Community Plan and Local Coastal
Program Ad Hoc Committee
of the Venice Neighborhood Council

MARINA PENINSULA--Subarea Review

June 3, 2024

Marina Peninsula – City Planning Proposed Residential Land Use Designations

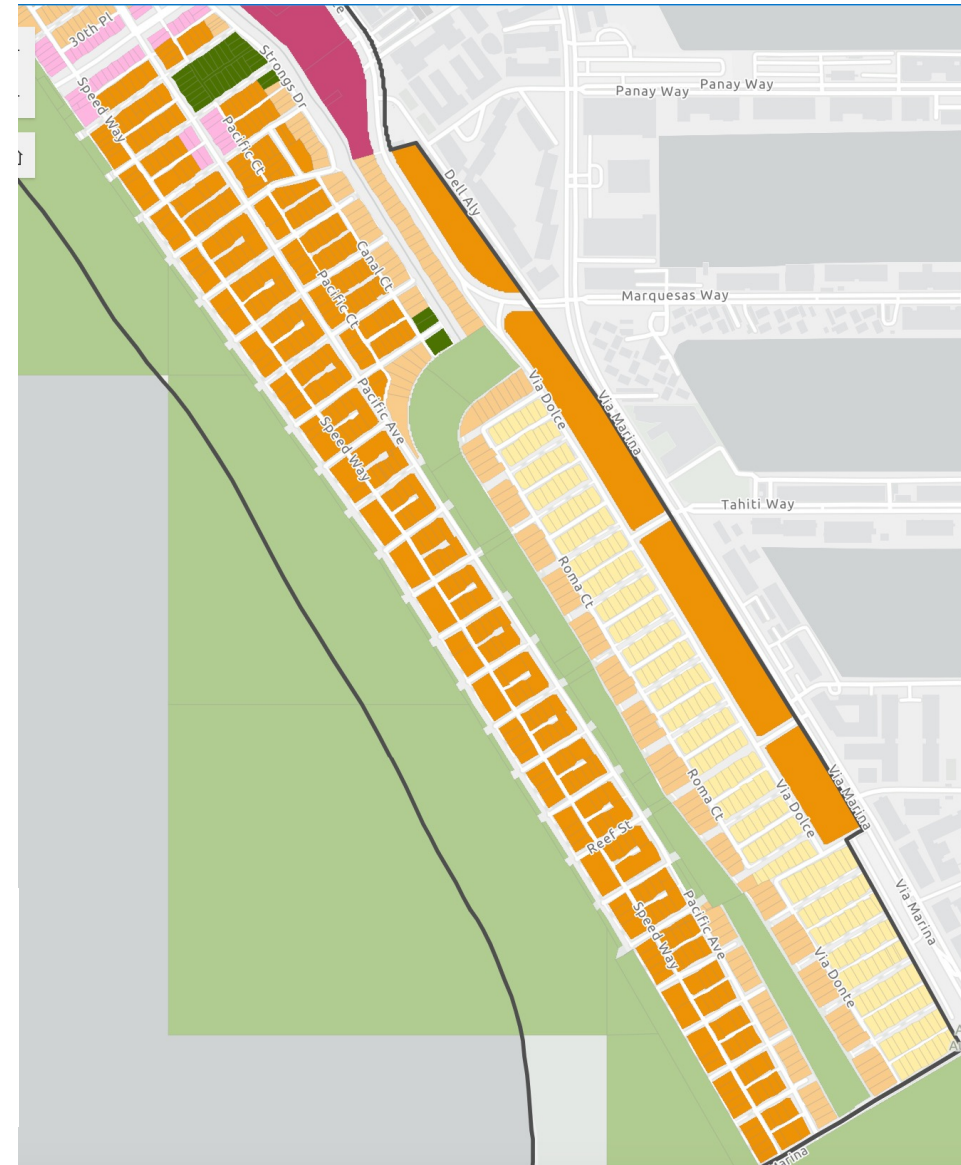
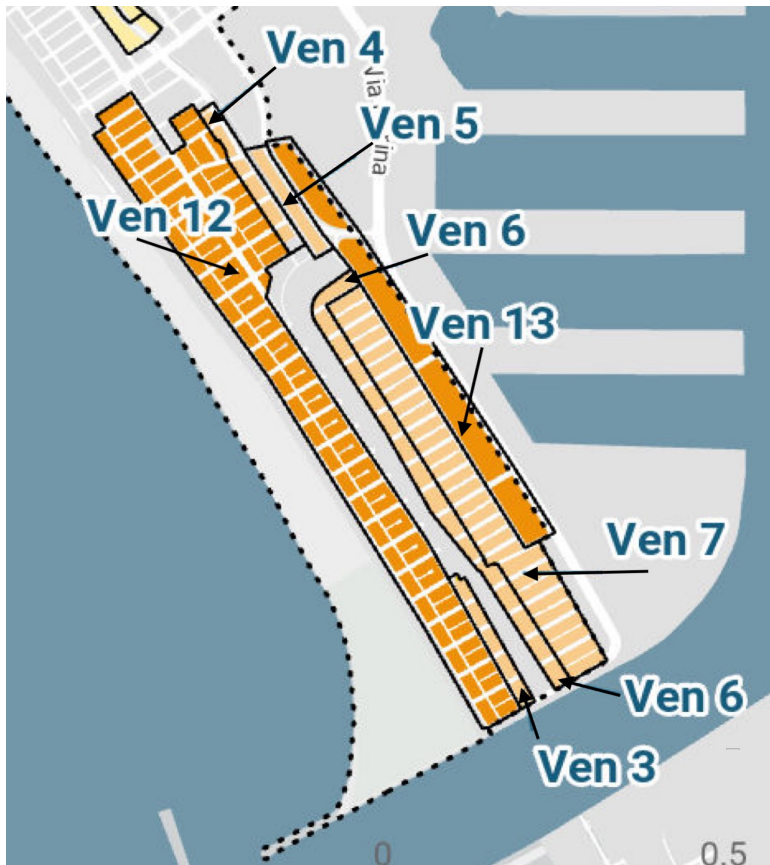
- For VEN 3, 6, and 7, which are now single-family zoning, I don't understand why they are being changed to multi-family (Low Medium Residential), with an imposition of FAR on those lots where it doesn't exist, and a limit on stories or height that's less than what's currently built.

- It's clear that the number one objective of City Planning is to allow for as much housing as possible. It obviously makes no sense where you have single family residential in Marina Peninsula East that you would upgrade it to multifamily residential, because it's already built out as single family. Why would the city do that?

- To reduce height and square footage allowances and to impose a FAR where there is none or reduce FAR where there is one existing is inappropriate. I should be allowed to build what the neighbor to my right and my left have already built, to maintain an existing look and feel. I don't think taking away what's currently allowed is appropriate.

The Venice Neighborhood Council recommends the following changes for the Marina Peninsula subarea to Planning's current proposal for the Venice Community Plan:

Low Residential (VEN 7) Silver Strand

- Lot Coverage: 65%
- Lot Consolidation: 0

Low Medium Residential (VEN 6) Silver Strand Lagoon Front

- Maximum Height: 30' to 36' *
- FAR: 1.25 (none)
- Lot Coverage: 65%
- Lot Consolidation: 0

Medium Residential (VEN 13) Along Via Marina

- Maximum Height: 45'
- FAR: 1.5 (?)
- Lot Coverage: 65%
- Lot Consolidation: 3
